Addendum 1
Solicitation 23-99776
GANC Connector Trail, Snowmaking & Lighting

This addendum serves to notify all bidders of the following changes to the solicitation documents:

Solicitation No.: 23-99776
Project Title: GANC Connector Trail, Snowmaking & Lighting

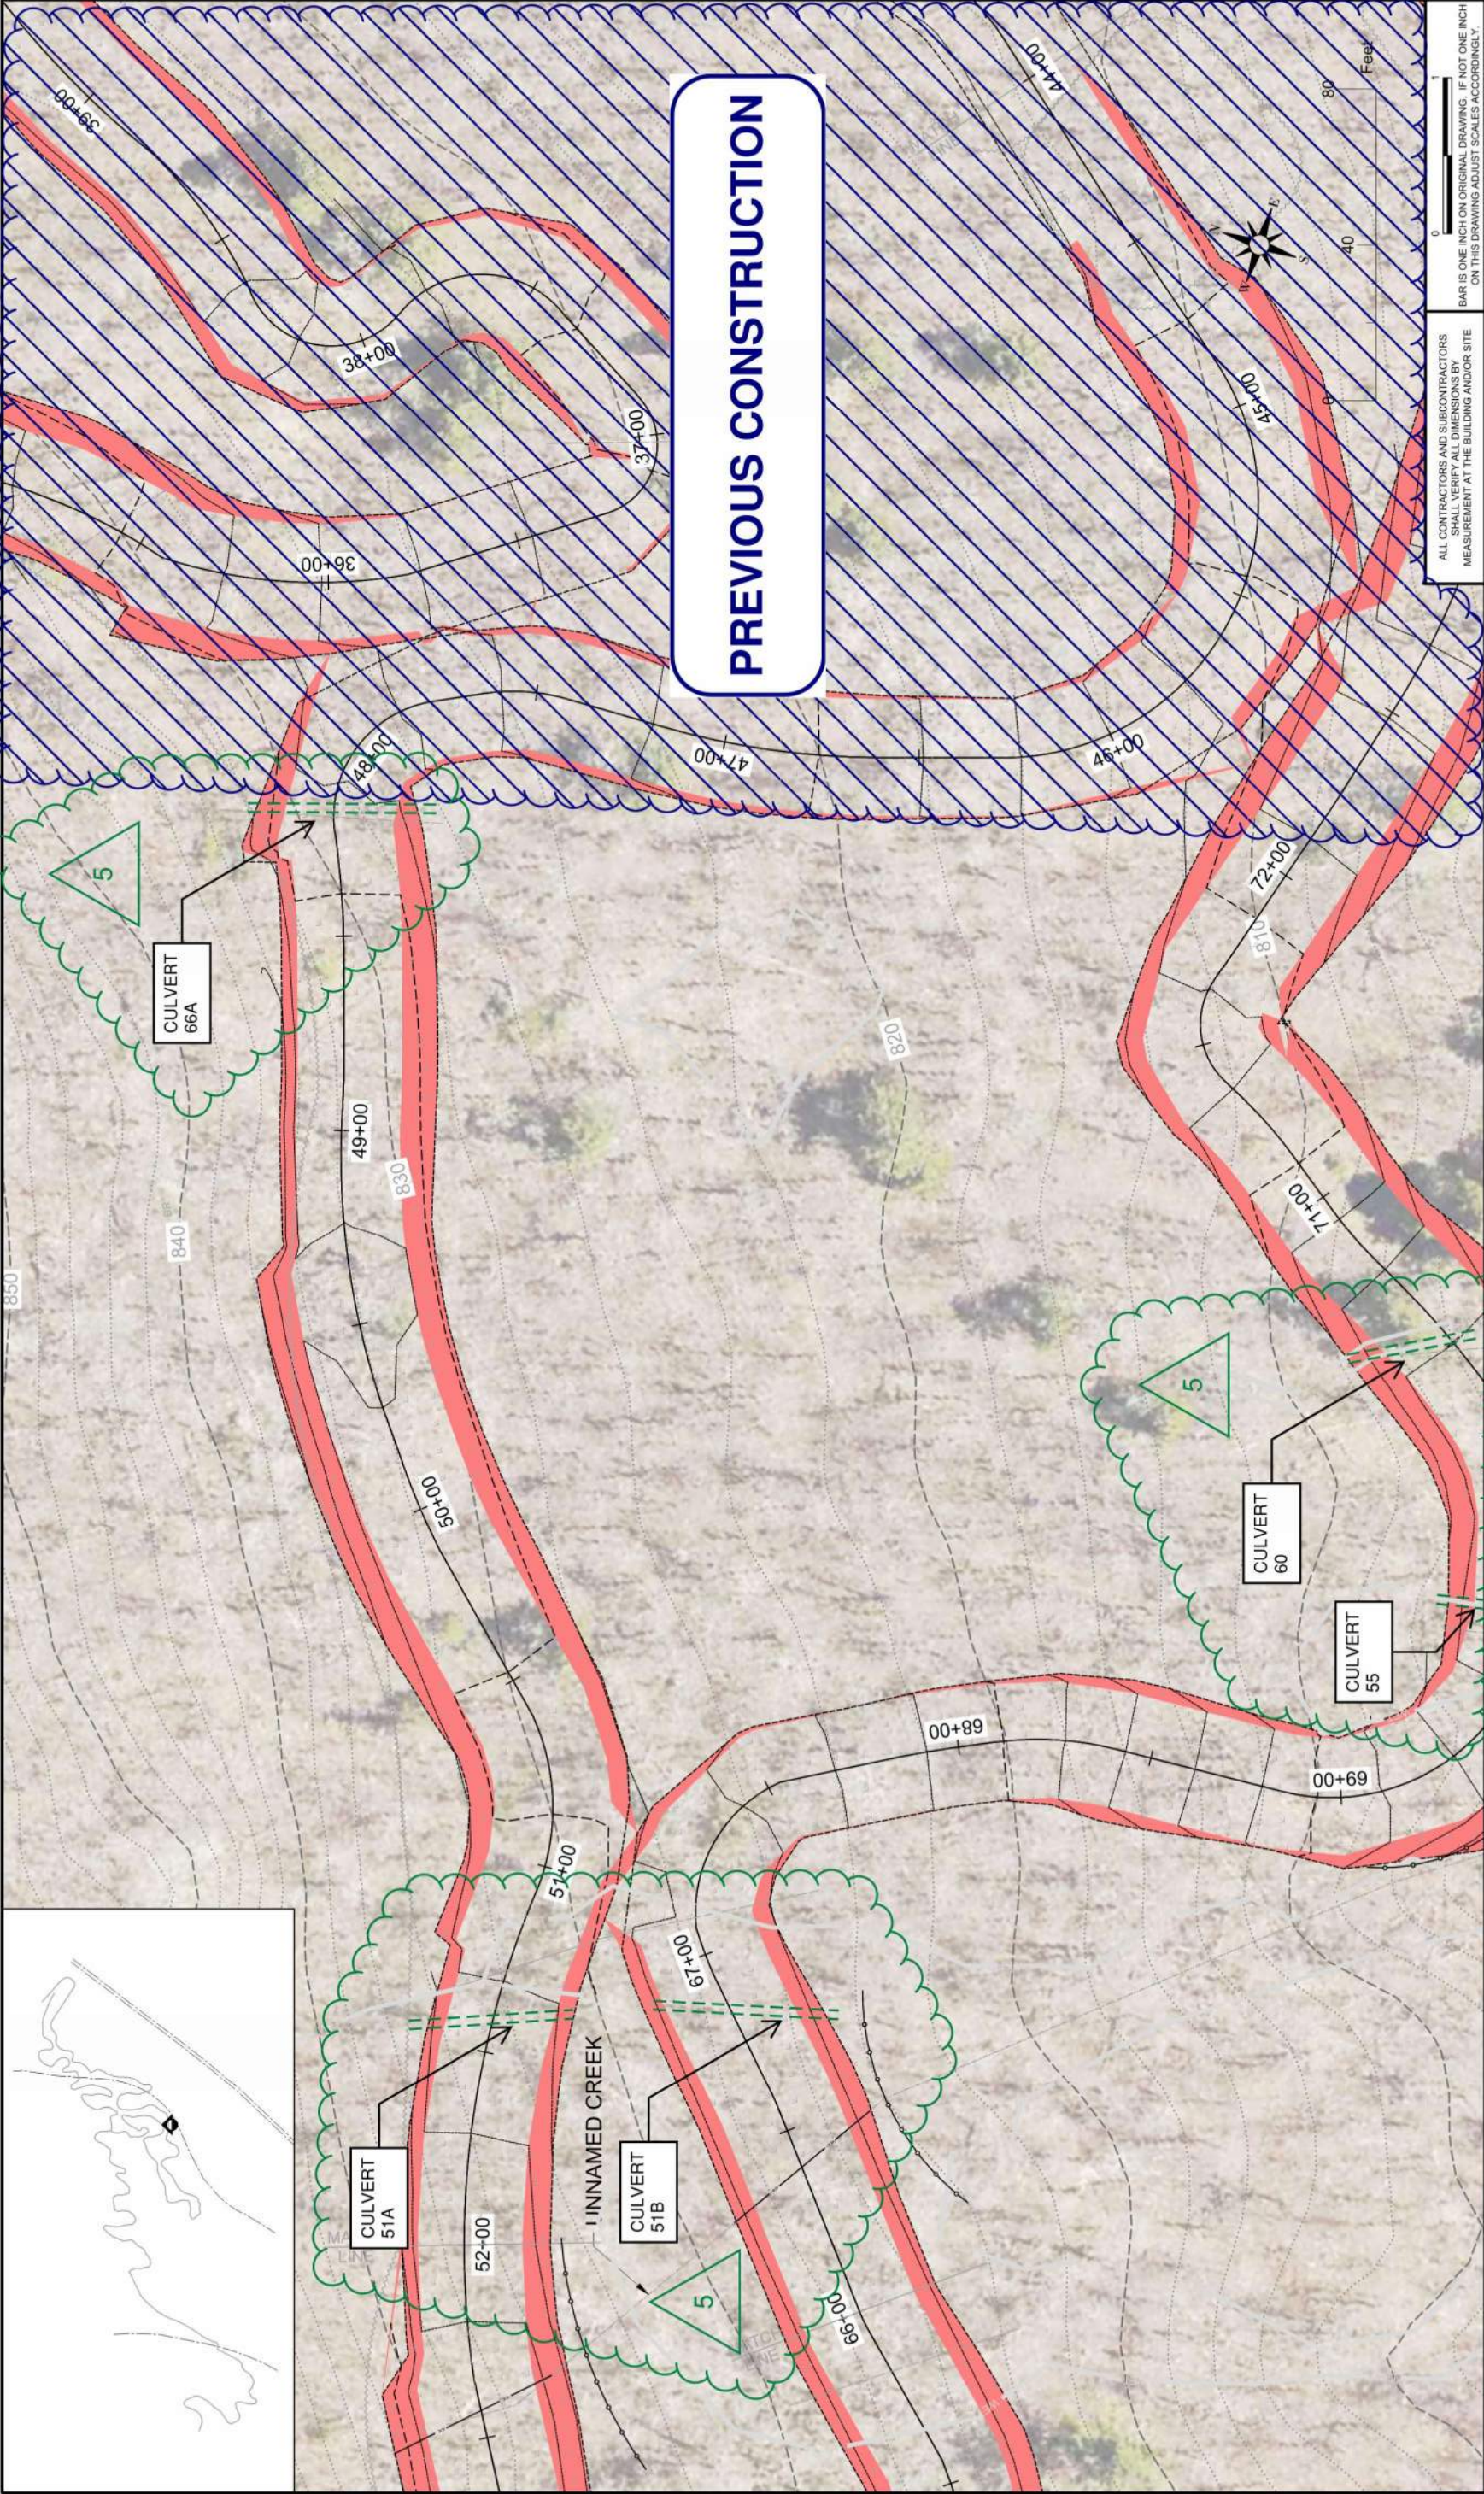
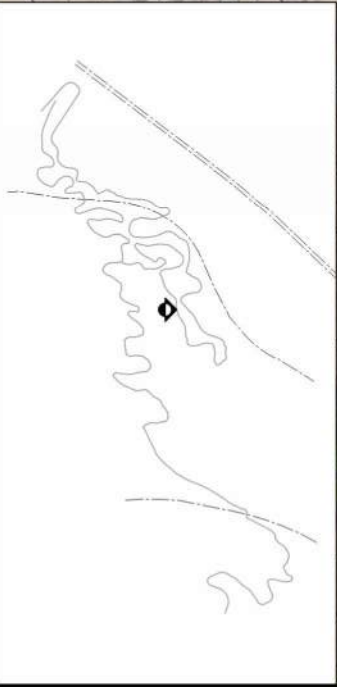
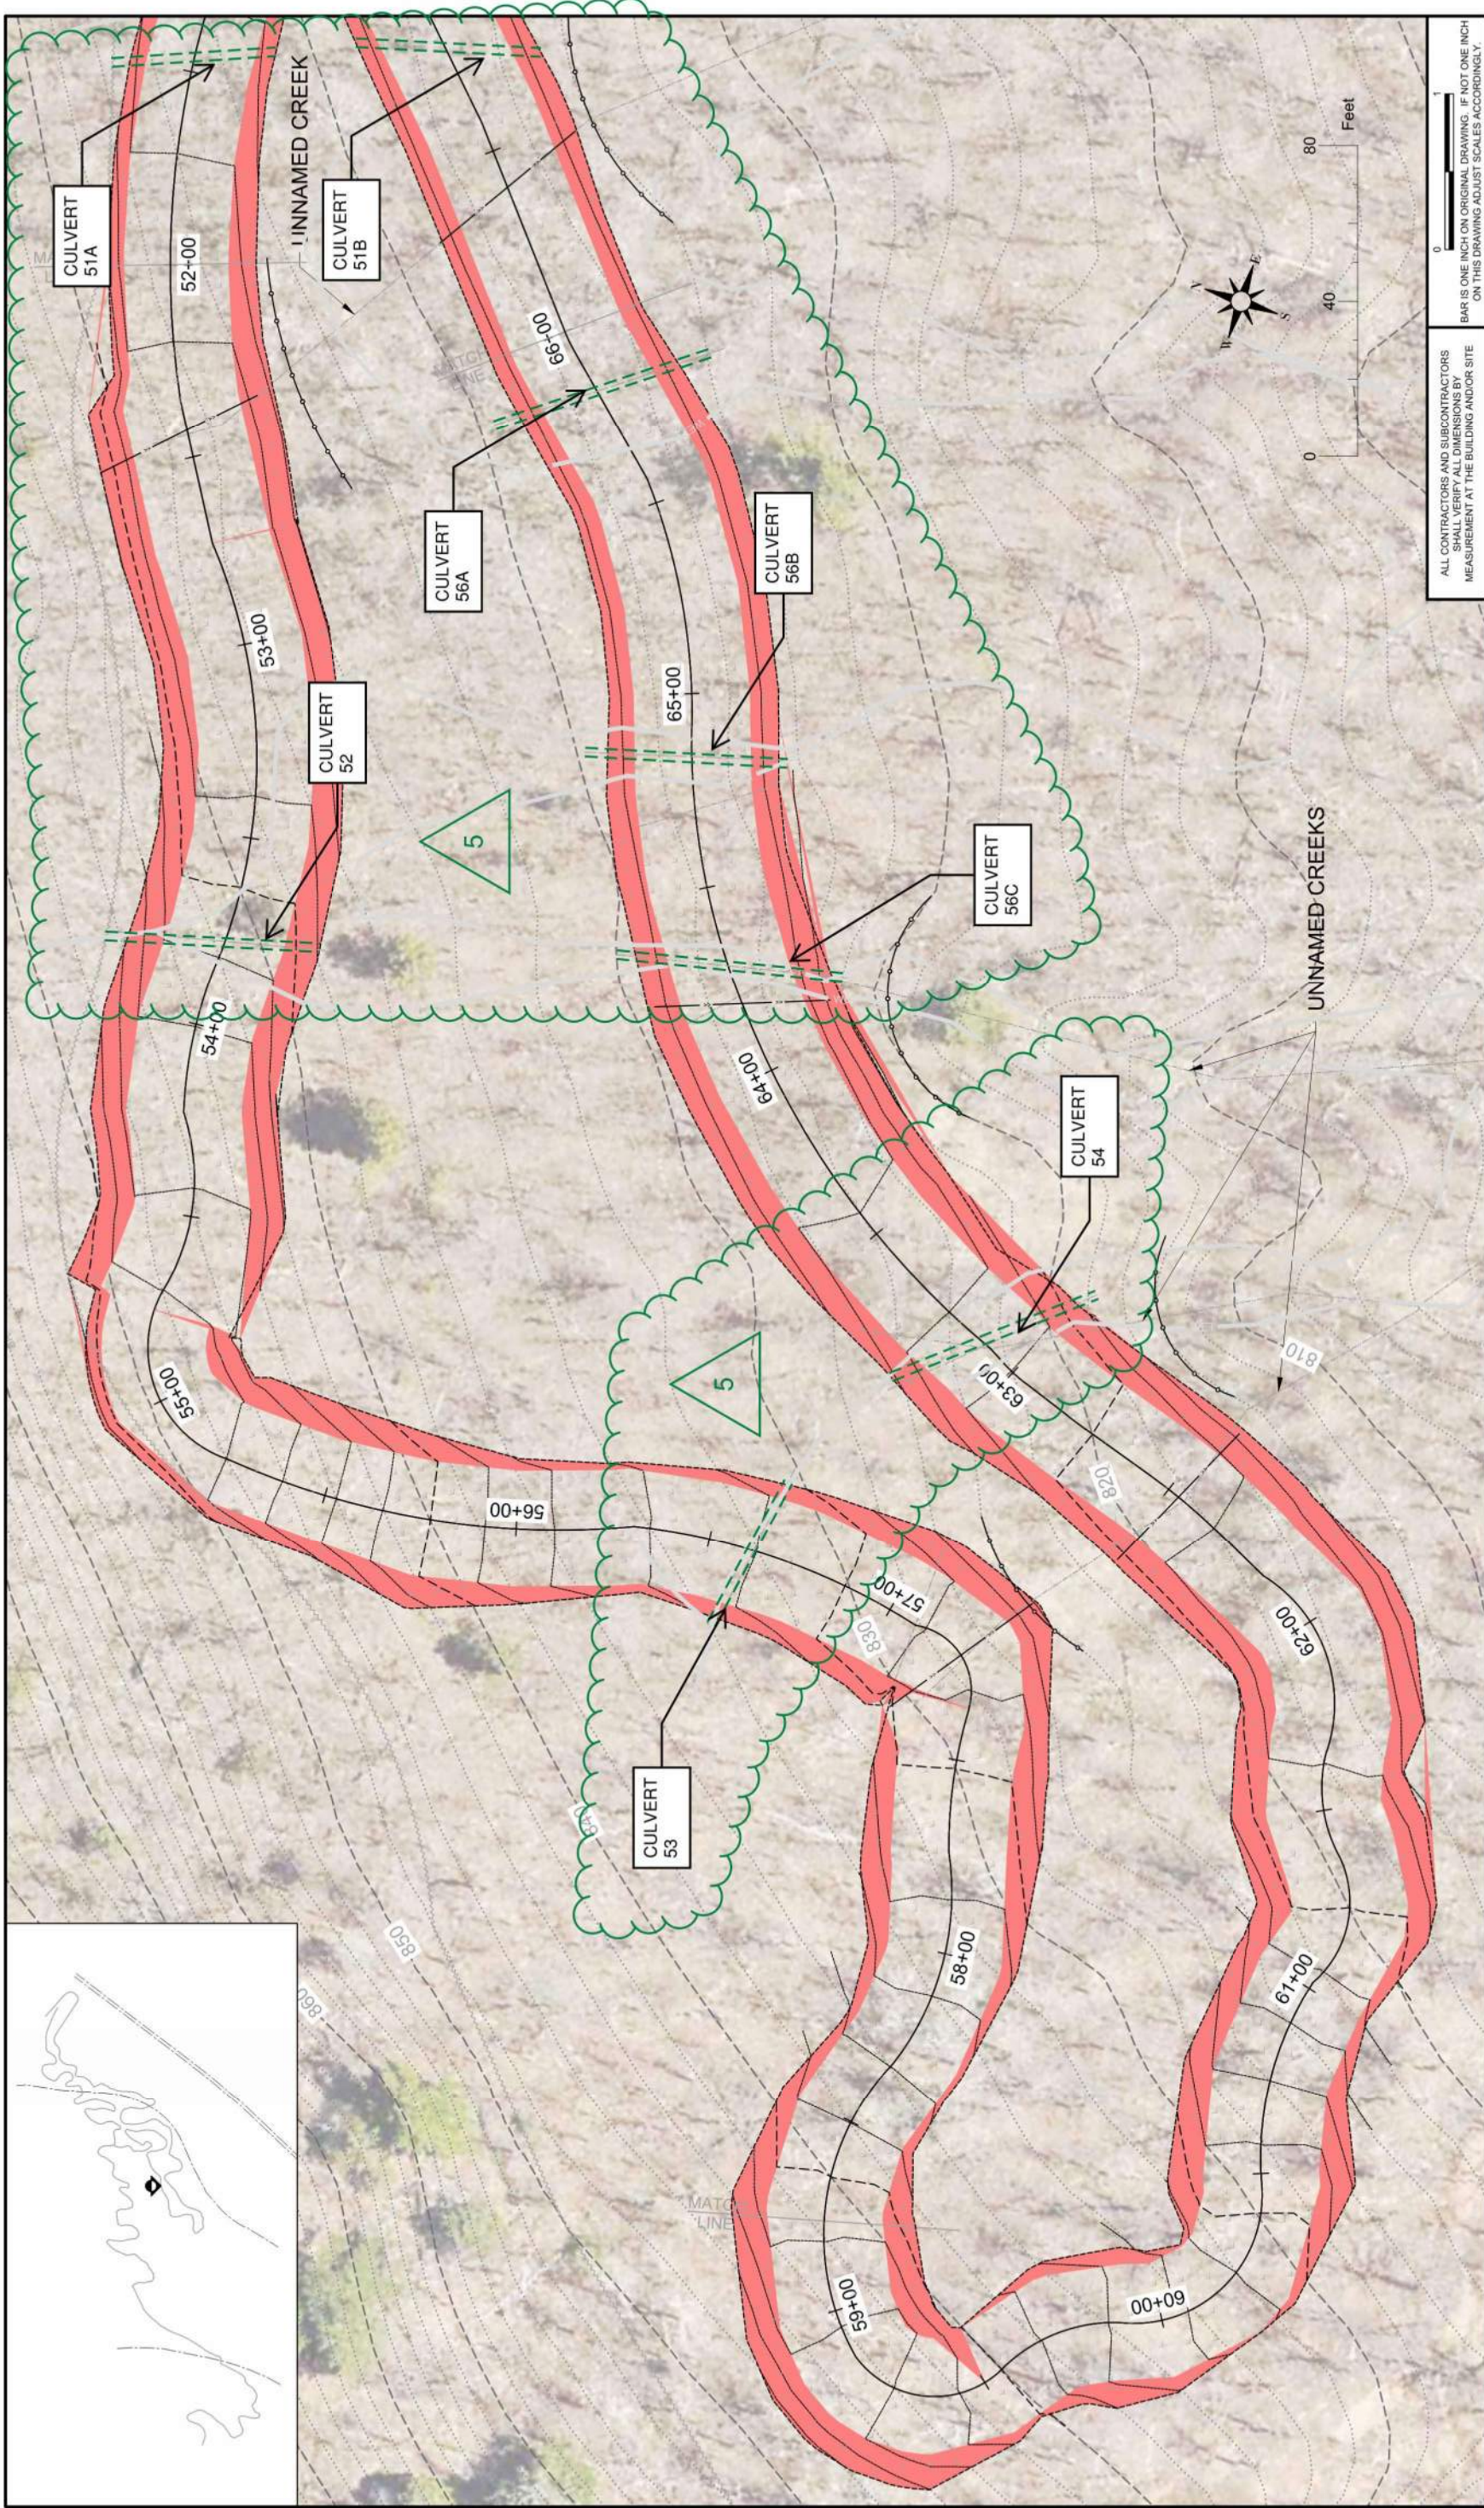
DESIGNED	JS	PROJECT NO.	16585.000
DRAWN	WD	DRAWING NO.	13
CHECKED	JG		
DATE	DATE		
NO.	ST	DESCRIPTION OF REVISIONS	
5	11/21/23	EM	ADDENDUM 5 - ADDED CULVERTS AND REVISED SWPPP
4	11/10/23	EM	ADDENDUM 4 - CONSTRUCTION OF 0.8K LOOP & CONNECTOR TRAIL
3	11/10/23	EM	ADDENDUM 3 - CONSTRUCTION OF 0.8K LOOP & CONNECTOR TRAIL
2	11/10/23	EM	ADDENDUM 2 - CONSTRUCTION OF 0.8K LOOP & CONNECTOR TRAIL
1	11/10/23	EM	ADDENDUM 1 - CONSTRUCTION OF 0.8K LOOP & CONNECTOR TRAIL
